**NOTICE OF A REGULAR MEETING  
BONDURANT PLANNING AND ZONING COMMISSION  
AUGUST 25, 2022**

**TITLE:** RETURN TO TABLE - RESOLUTION NO. PZ-220728-19: Considering recommended approval of the Wisteria Crossing Preliminary Plat

BONDURANT, IOWA  
WISTERIA CROSSING PRELIMINARY PLAT  
STORMWATER CALCULATIONS

GRADING & UTILITIES

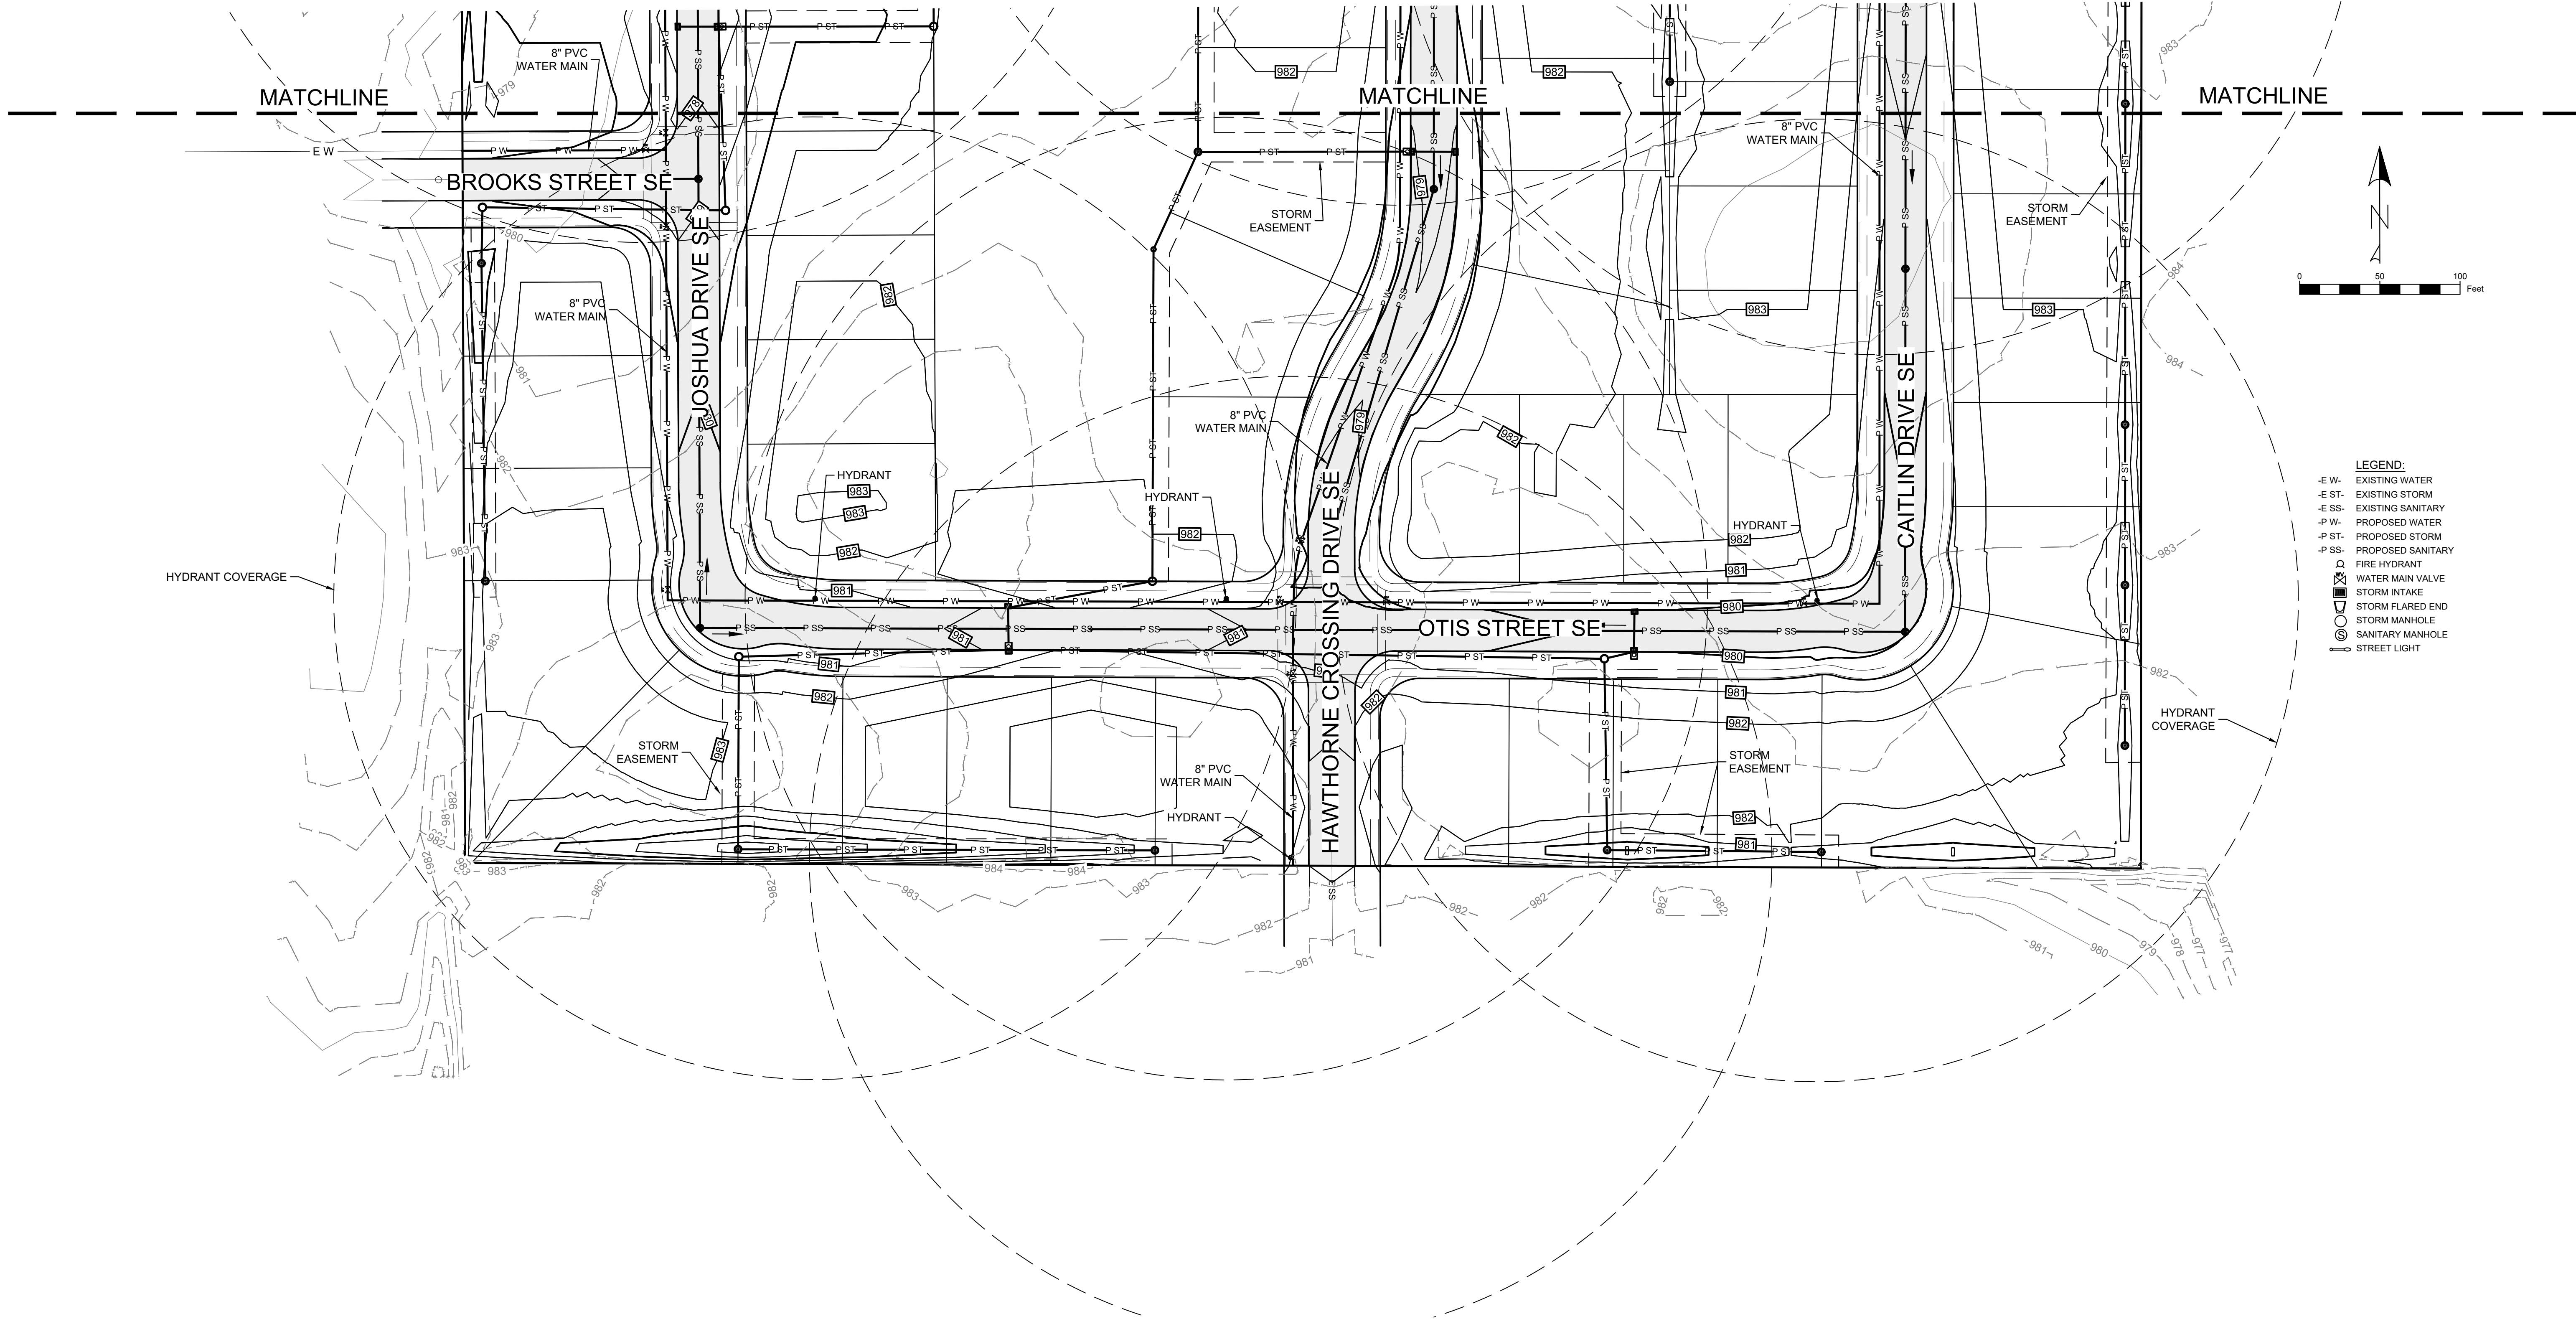
The stormwater calculations and the updated preliminary plat show the concept for addressing runoff from the rear yard areas located to the east of the east boundary of Wisteria Crossing. The concept plan involves the construction of a continuous north south swale into which the surface runoff would flow. Low flows would be absorbed into the ground and collected in a perforated under drain. Larger volumes of runoff would be captured in intakes located at low points in the swale. This concept for collecting the rear yard stormwater drainage is similar to the concept used in several recent subdivisions. The overall concept presented by Stubbs Engineering to intercept and convey the runoff from the rear yards to the east appears to be satisfactory.

8. The proposed release rate from the site is 49.97 cfs. The 49.97 cfs release rate would be satisfactory as it is less than the allowable 50.20 cfs.
9. The release pipe from the stormwater detention basin is routed northerly and discharges overland to a low area located just north of Wisteria Crossing.

13. The detention basin includes an overflow section. Any basin overtopping would be routed northerly to the discharge area to the north of the site.
14. The preliminary plat shows a single wet bottom detention basin.

15. The pool elevation in the detention basin is 976.40.
16. In a 100 year storm event the maximum water surface elevation in the stormwater detention basin is 980.24, or an increase of 3.84 feet above the pool elevation.

17. The rear yard elevations to the east of the southeast corner of the site are in the range of 982 to 983. In a 100 year storm event there is approximately two feet of head available between the rear yard areas and the maximum hydraulic grade line in the detention basin. The storm sewers that will be designed as part of the construction plans need to recognize this limitation.

18. The preliminary plat indicates the overflow elevation for the detention basin is 981.30 or 1.06 feet above the maximum 100 year pond elevation. The City normally requires one foot of freeboard. The preliminary plat and stormwater calculations would indicate this level of freeboard is provided.
